**DEPARTMENT OF TRANSPORTATION
STATE OF GEORGIA**

FILE: NH-000-0085-02(153), Fulton County
P.I. No.: 762380
SR 400/I-85 Connector Ramps

SUBJECT: IMPLEMENTATION OF VALUE ENGINEERING STUDY ALTERNATIVES

SUBJECT Value Engineering Study Report Responses

I-85 SOUTHBOUND TO SR 400 NORTHBOUND

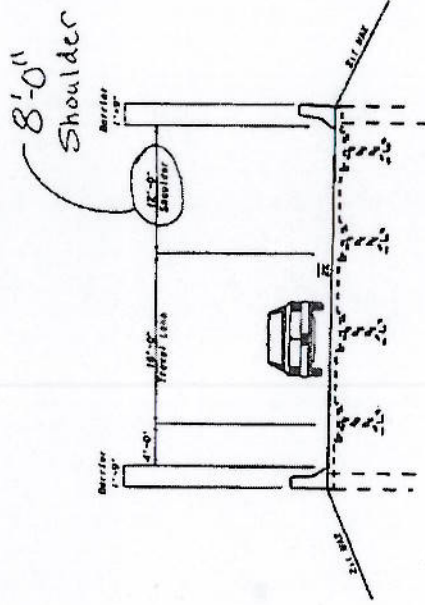
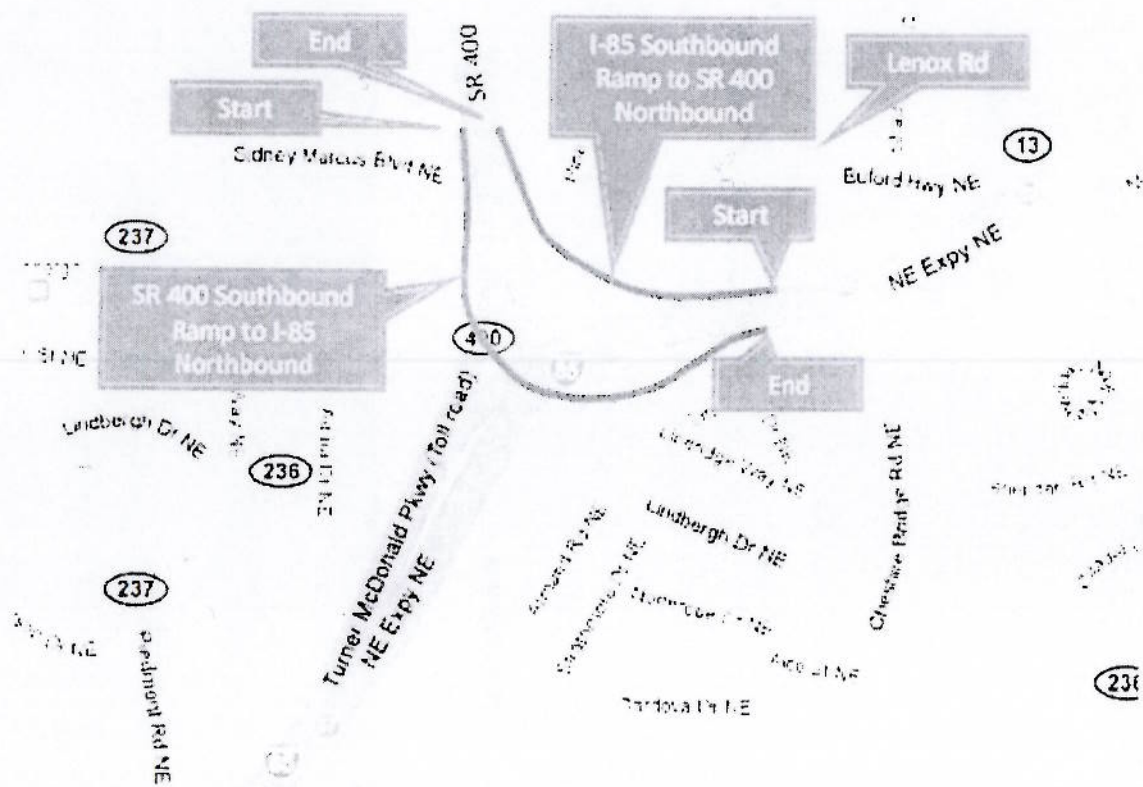
Recommendation SS-2: Is there barrier along the left and/or right side of this ramp? YES If on the right, is there a 10' shoulder and then a 2' offset to barrier or is it 10' from edgeline to face of barrier? The original VE recommendation was to reduce lane width by 2 ft and reduce the right shoulder width by 2 ft to 10 ft (from edge of travel to face of barrier). HNTB's response was to maintain 16 ft travel lane and reduce outside shoulder width by 4 ft from 12 ft to 8 ft (from edge of travel to face of barrier). I have included a markup of the original typical section to illustrate this change (Sheet 1 of 2). Please note when reviewing Sheet 1 of 2 that the current concept has the proposed SR 400 NB bridge as a completely separate structure; therefore, the original typical section in the two-lane area where the SR 13 and SR 400 ramps overlap does not apply.

This section is no longer applicable.
Existing SR13 and proposed SR400 bridges
will be separate structures.
